ATTACHMENT (4)

UNIT 2

TECHNICAL SPECIFICATION

**Baltimore Gas & Electric Company  
Docket Nos. 50-317 and 50-318  
November 1, 1995**

FIGURE 1, PRE-OUTAGE ELECTRICAL DISTRIBUTION CONFIGURATION

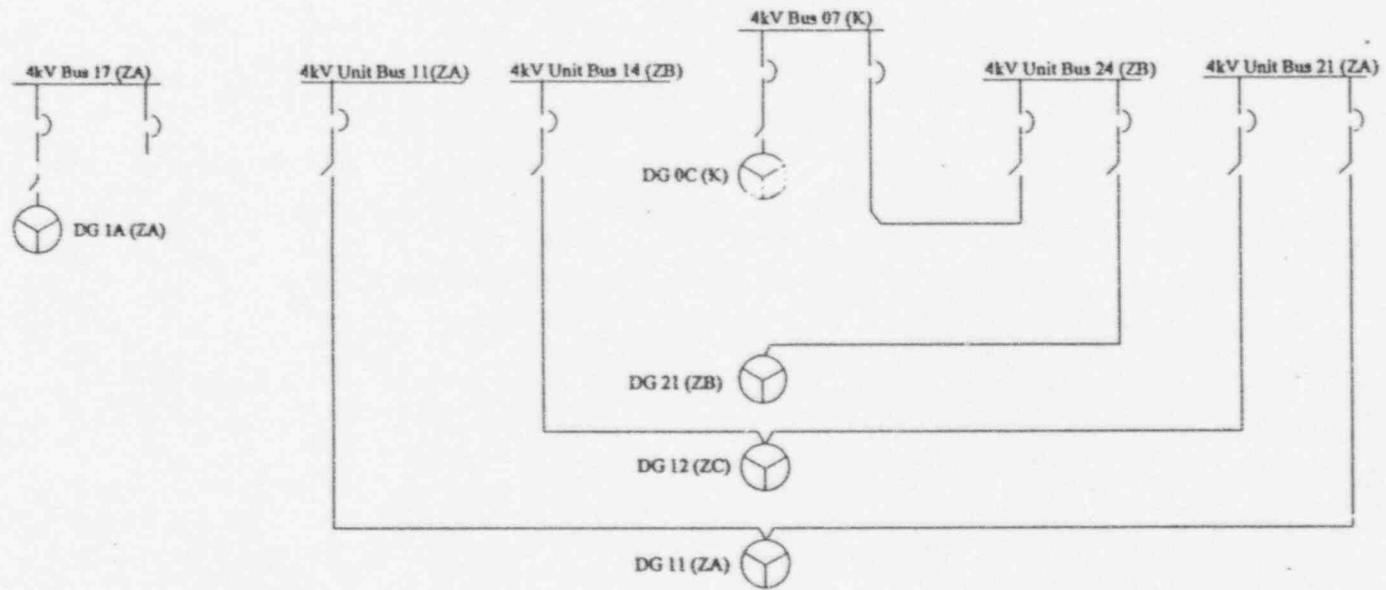
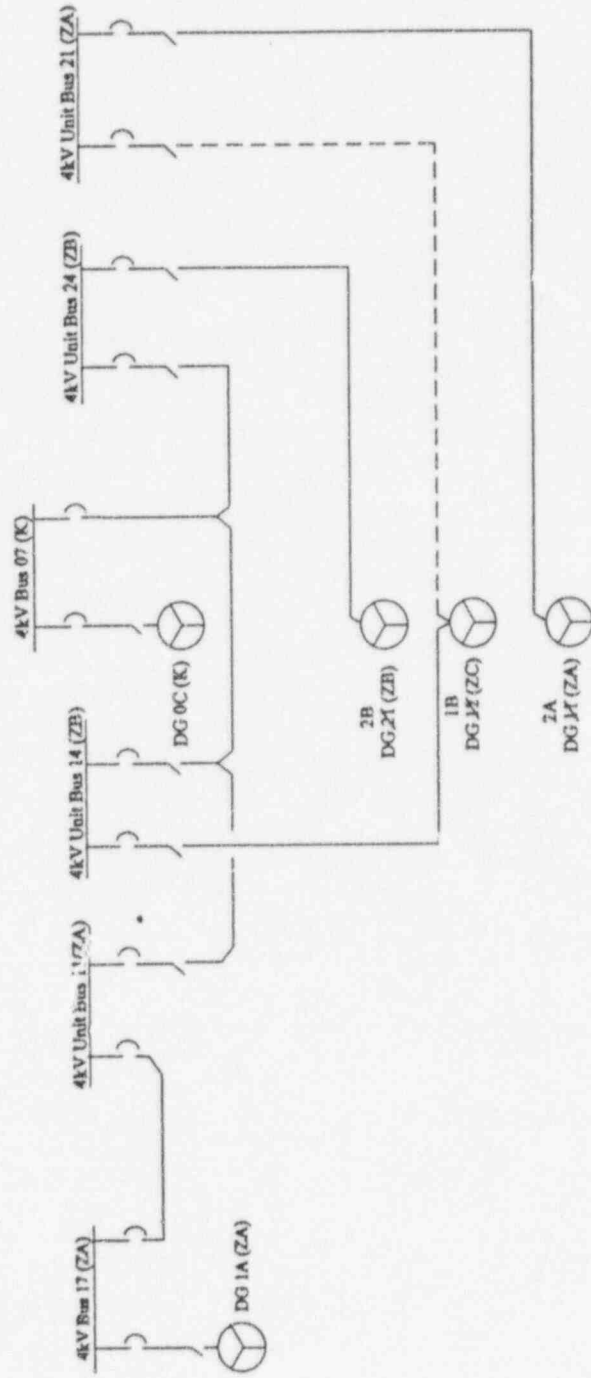
--- Auto-start, auto-load capability has been eliminated.

**FIGURE 2, POST-OUTAGE ELECTRICAL DISTRIBUTION CONFIGURATION**
